ADDENDUM #1 – FEBRUARY 22, 2024

**RE: COQUILLE SCHOOL DISTRICT
Bus Maintenance Building
Project #22.97**

**FROM: HGE ARCHITECTS, Inc.
333 South 4th Street
Coos Bay, Oregon 97420
541-269-1166**

7 MOUNTING BLOCK
3" = 1'-0"

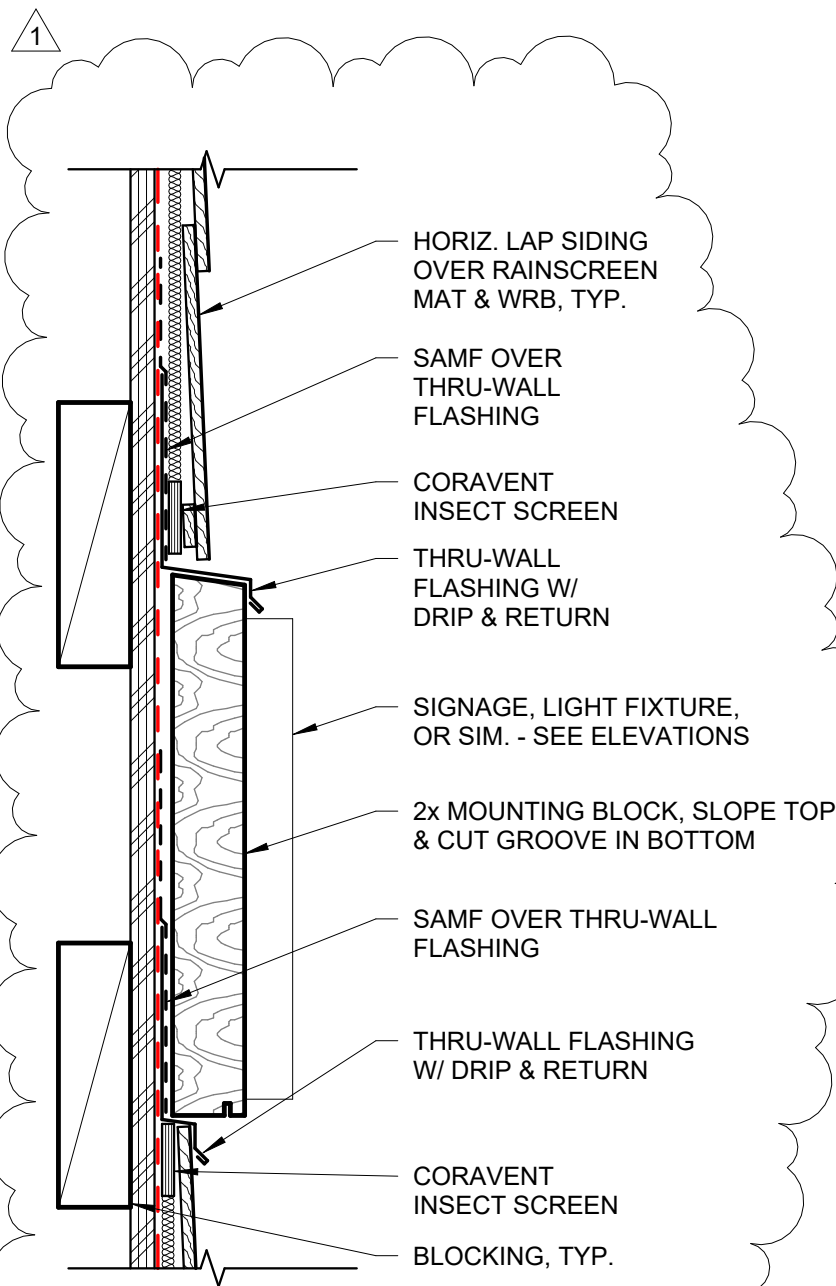
1. **Sheet A2.1 – Floor Plans:** REPLACE single drinking fountain with ADA bi-level drinking fountain.
2. **Sheet A3.1 – Building Sections & Details:** REPLACE with REVISED Sheet A3.1 – Building Sections & Details, attached. Revisions include addition of Detail 7 – Mounting Block.

2 E-W SECTION @ BREAK ROOM / HALL / OFFICE
1/4" = 1'-0"

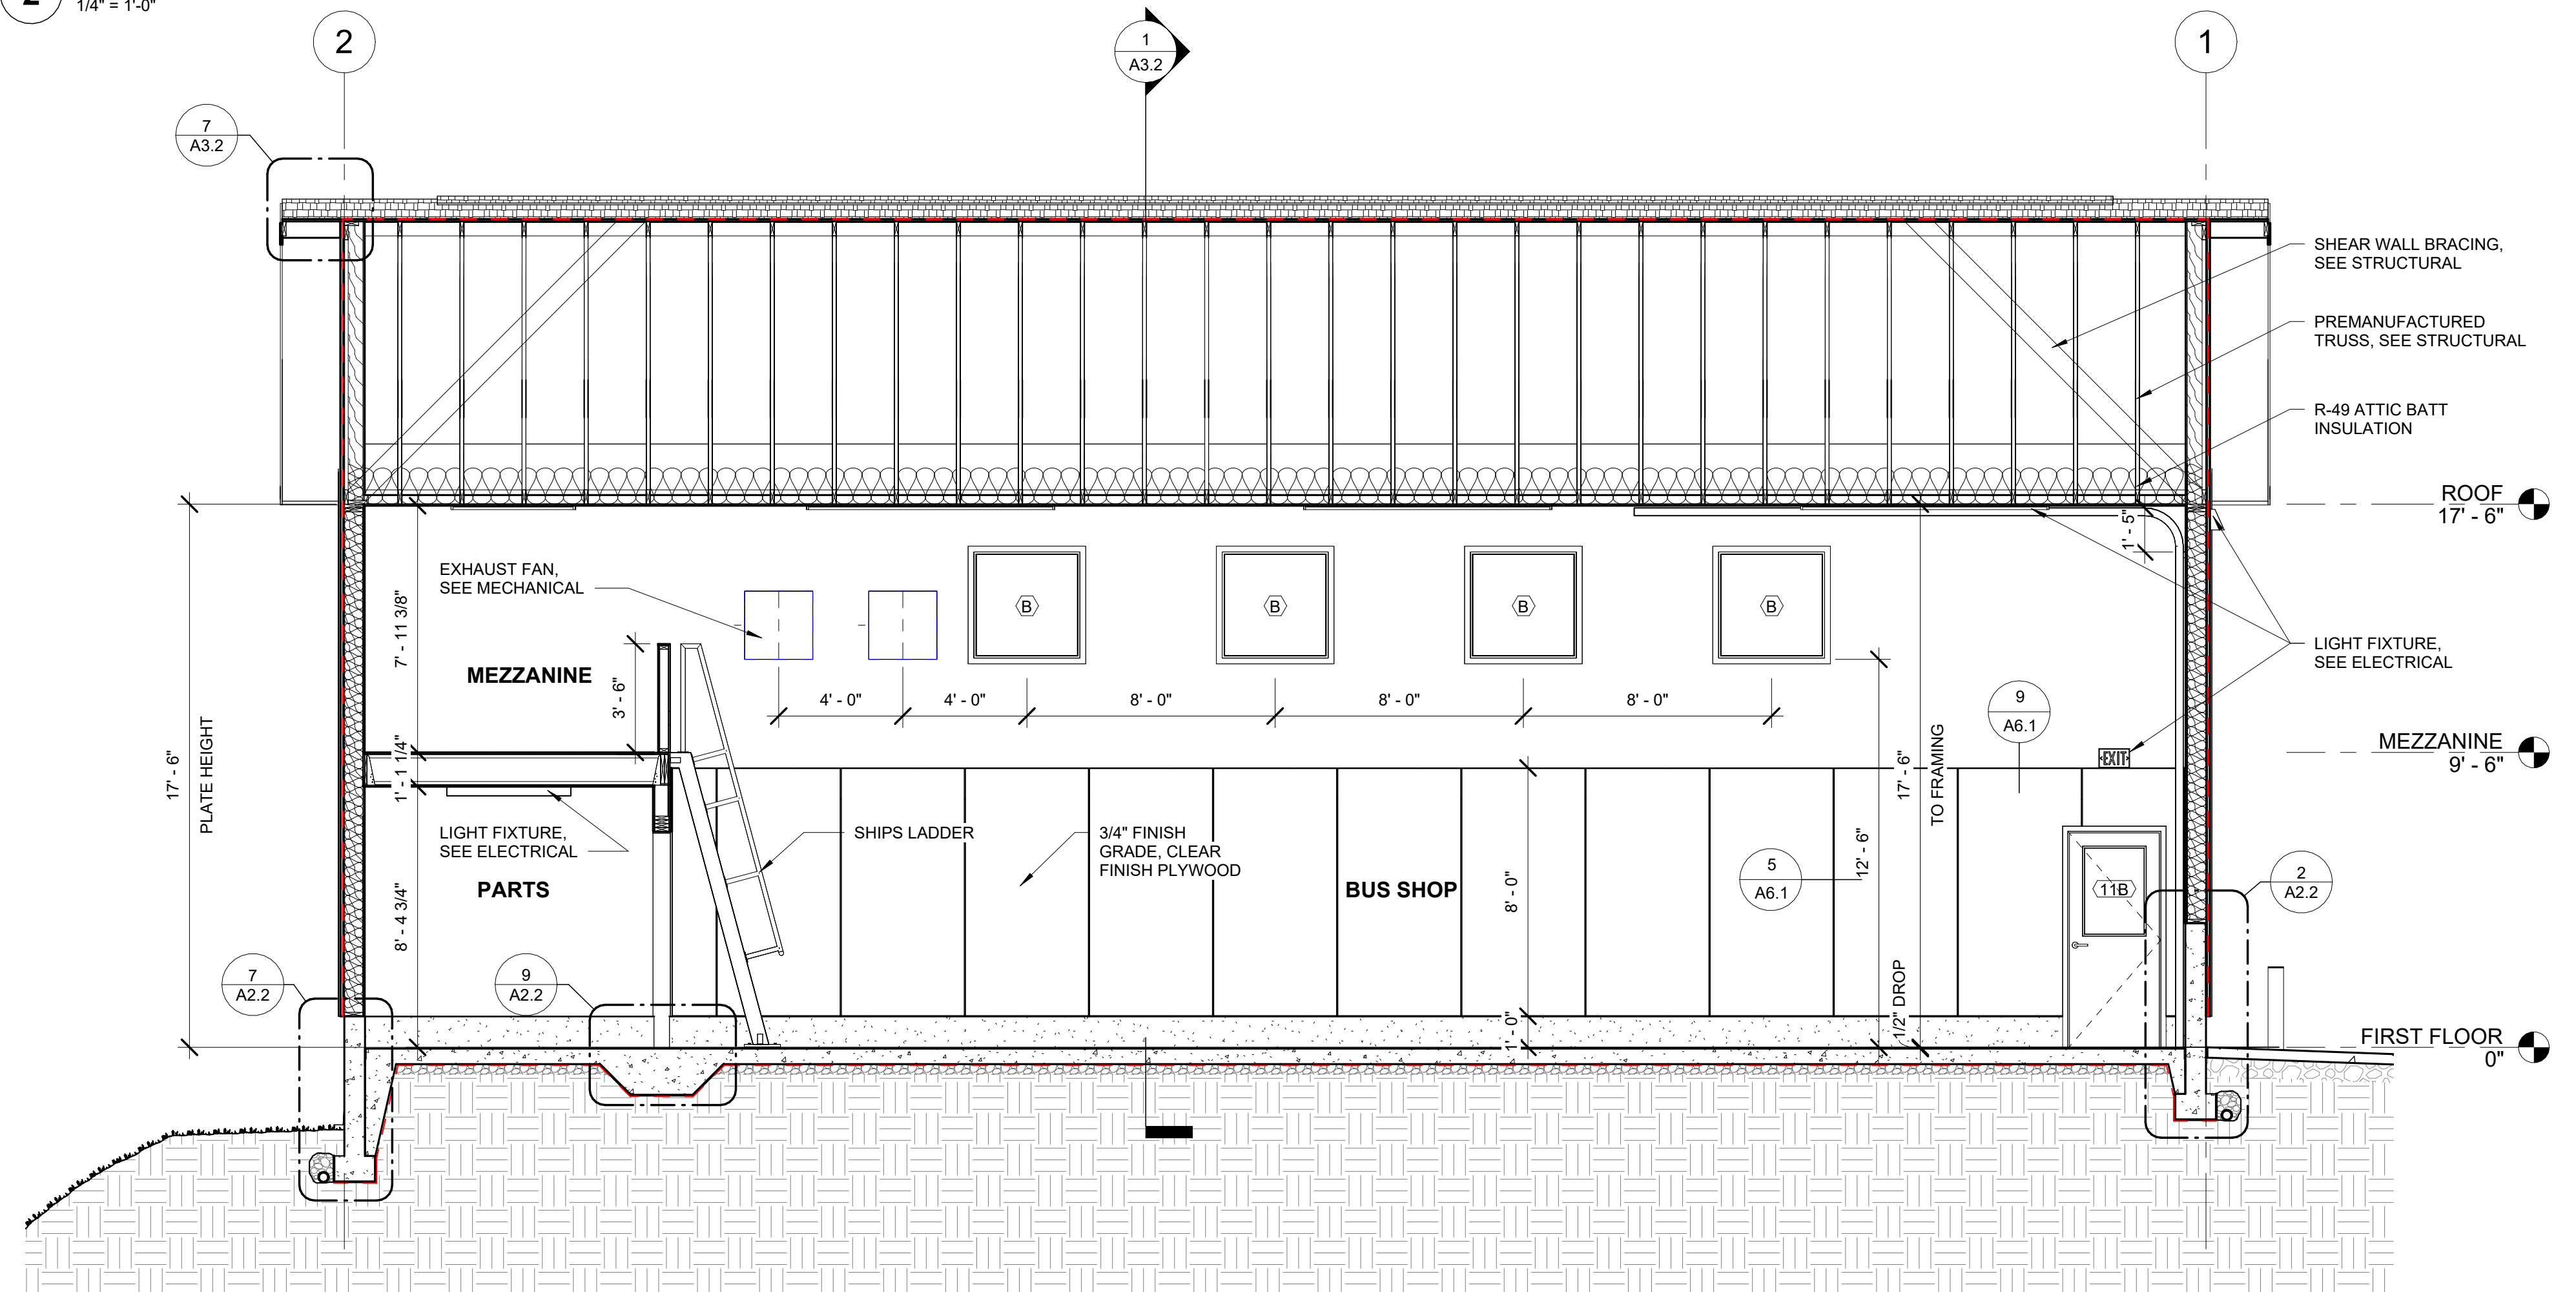
3. **Sheet A3.2 – Building Sections & Details:** REPLACE with REVISED Sheet A3.2 – Building Sections & Details, attached.
 - a. **Revision Summary:**
 - i. **Details 2, 6, & 8:** Added note: “(3) 3”Ø vent holes each joist bay.”

- ii. **Detail 2 & 6:** Added insulation baffle at blocking between I-joists. Deleted “14-inch” from note “14-inch wood I-joists, see Structural.”
 - iii. **Detail 4:** Added note: “(3) 1-1/2”Ø vent holes each joist bay.”

DOOR TYPES
1/4" = 1'-0"

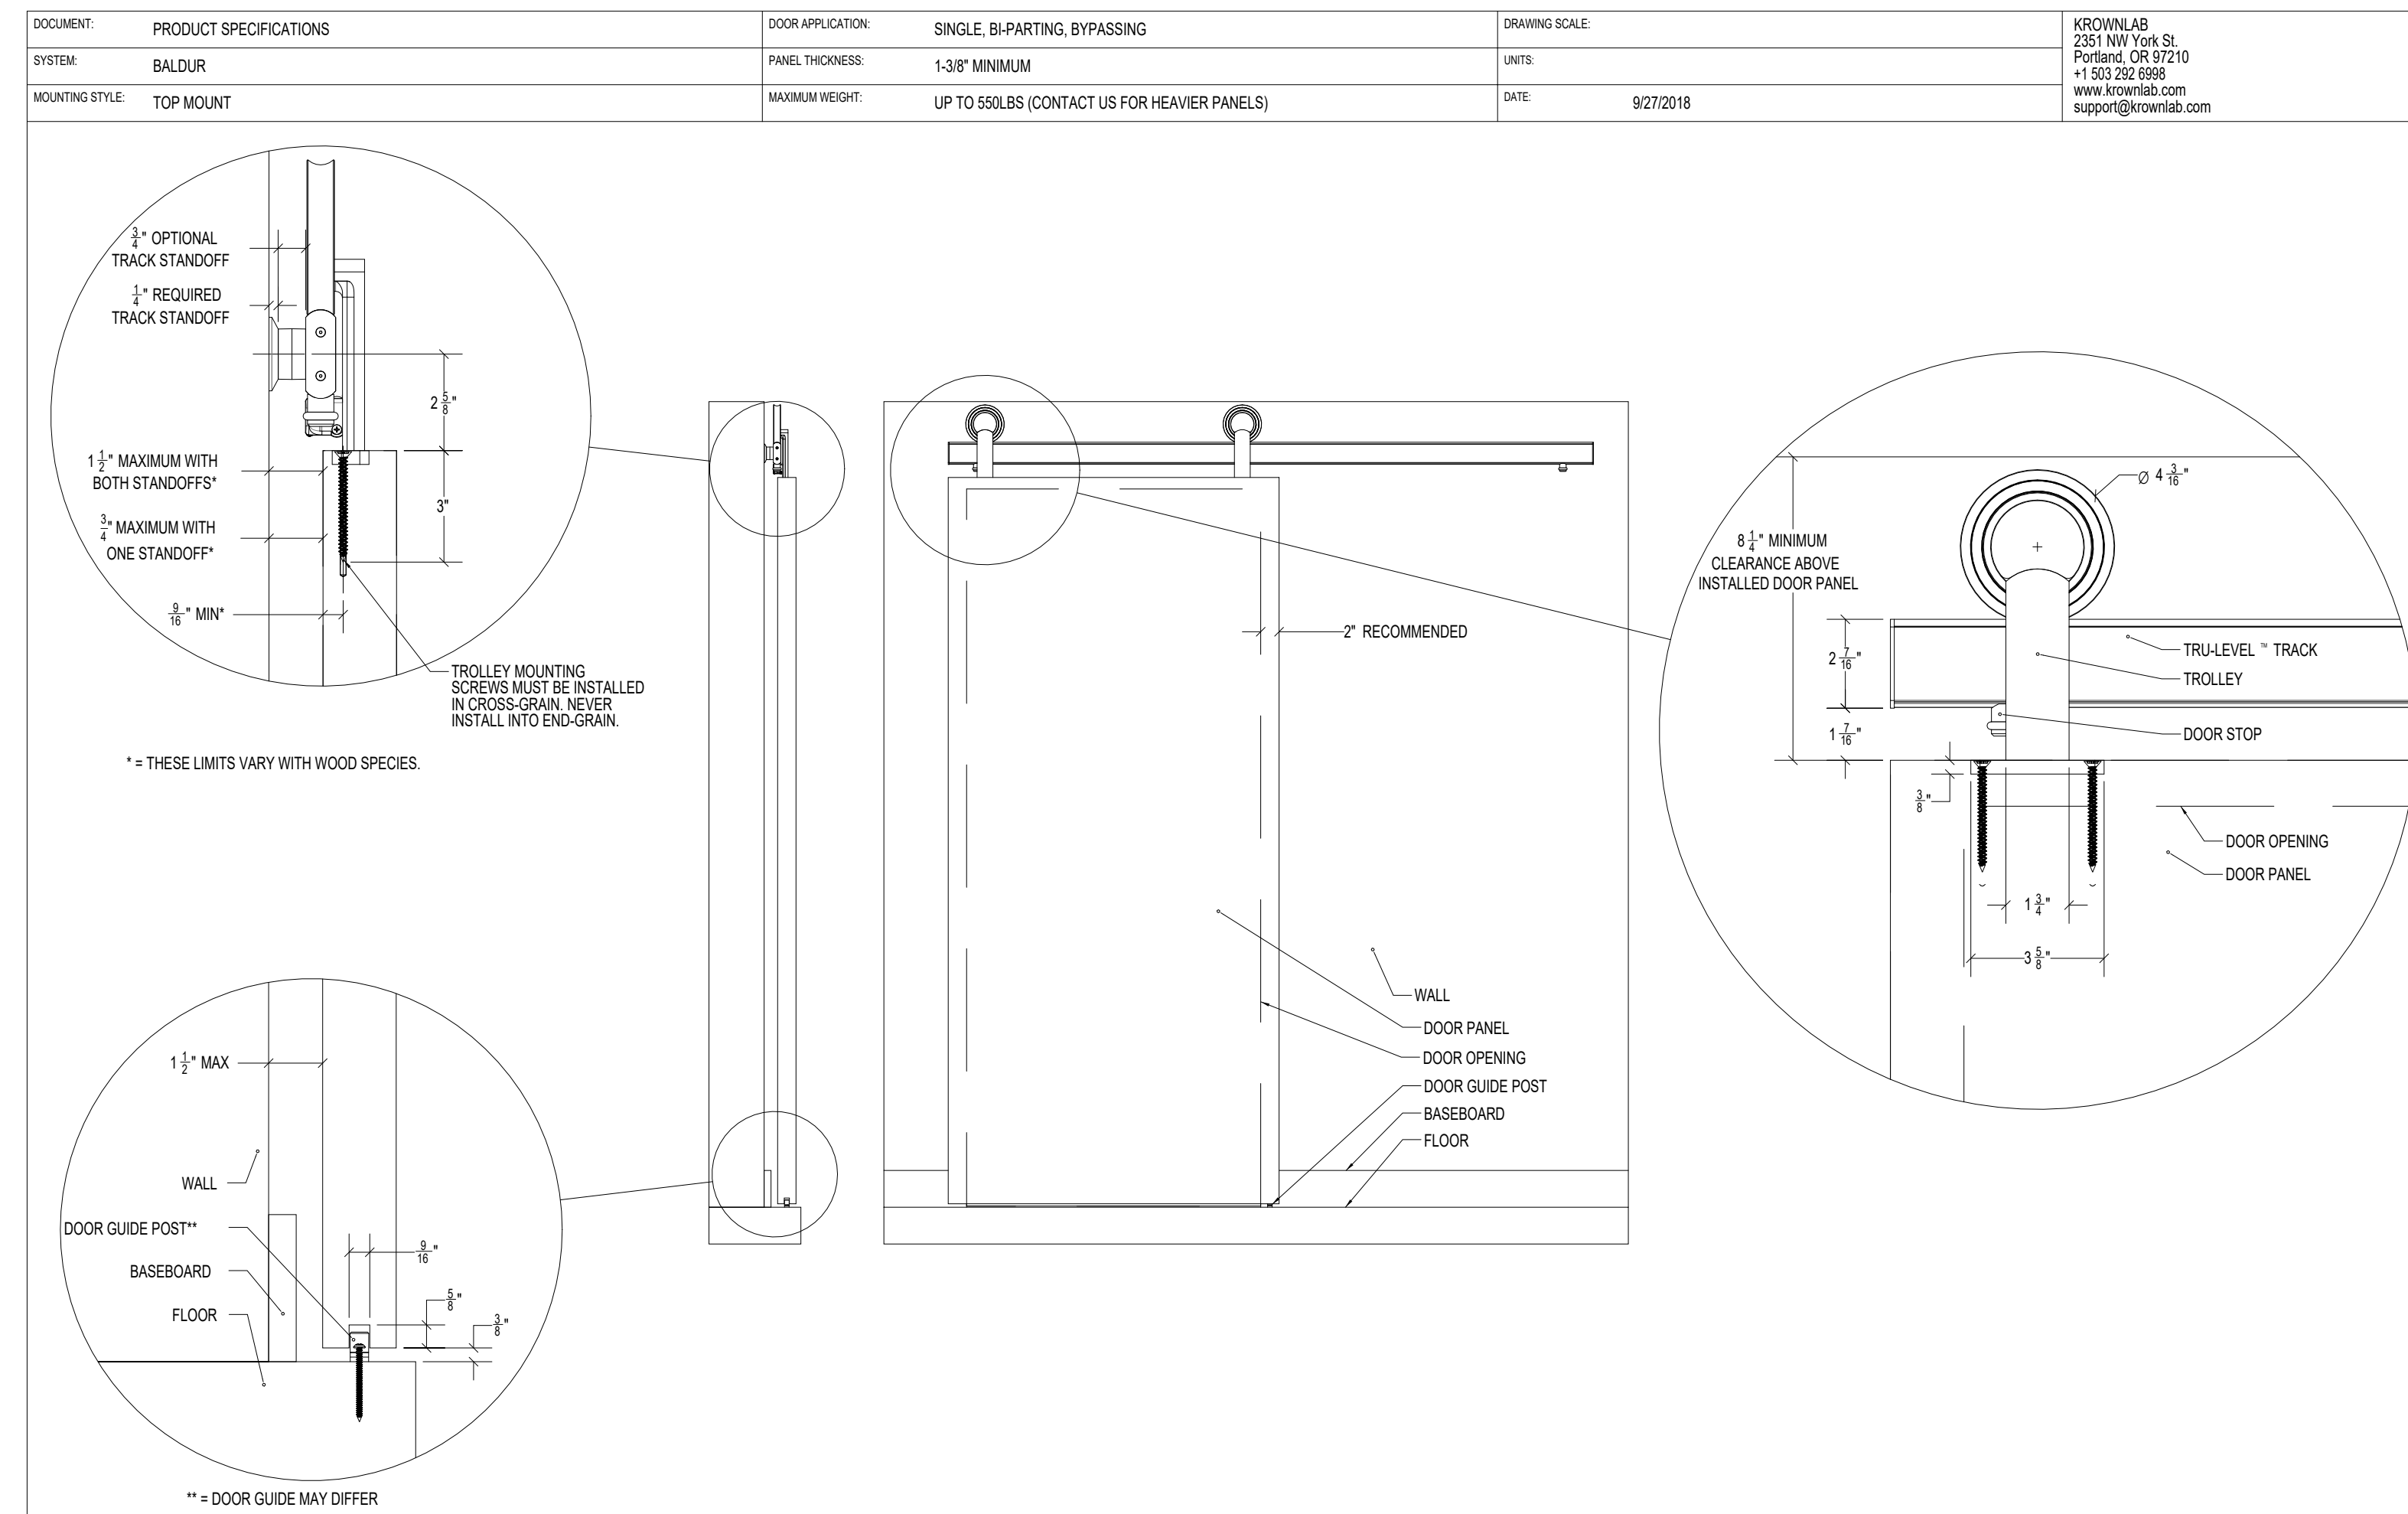
- a. **Revision Summary:**
 - i. Added Door Type B, Vision Glass Door.
 - ii. Changed Door 1A & 8A to Type C
 - iii. Changed Door 1B & 2 to Type B.
5. **Sheet S2.1 – Foundation Plan:** ROTATE Detail Callout 4/S4.2 at exterior column footing.

4 EXTERIOR WOOD POST FOOTING ON CONCRETE PEDESTAL
SCALE: 3/4"=1'-0"

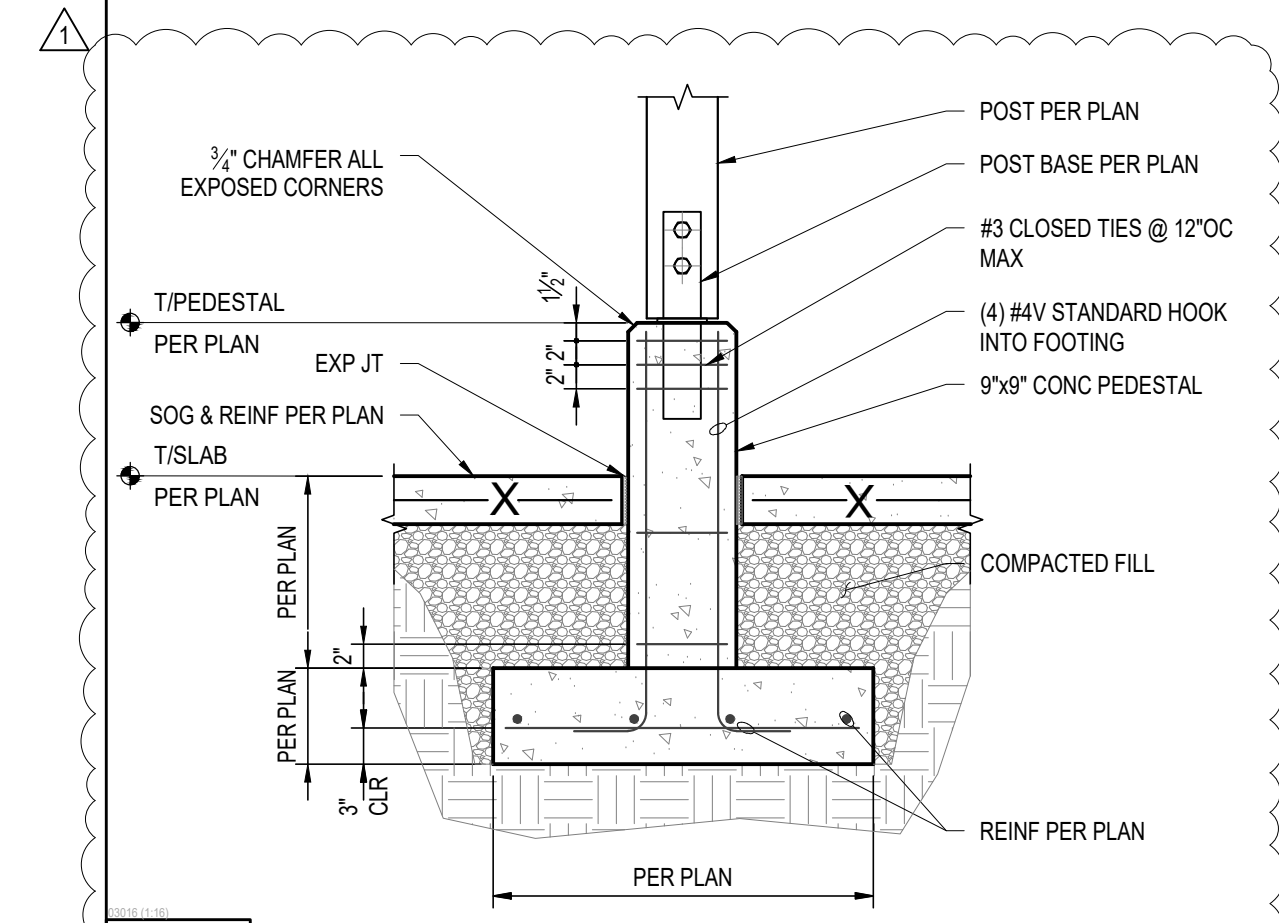
6. **Sheet S2.3 – Roof Framing Plan:** ADD Detail Callout 13/S6.1 at roof ridge.
7. **Sheet S4.2 – Foundation Details:** REPLACE with REVISED Sheet S4.2 – Foundation Details, attached. Revisions include replacement of Detail 4 – Exterior Wood Post Footing on Concrete Pedestal, formerly “Interior Thickened Slab Footing at Wood Post.”
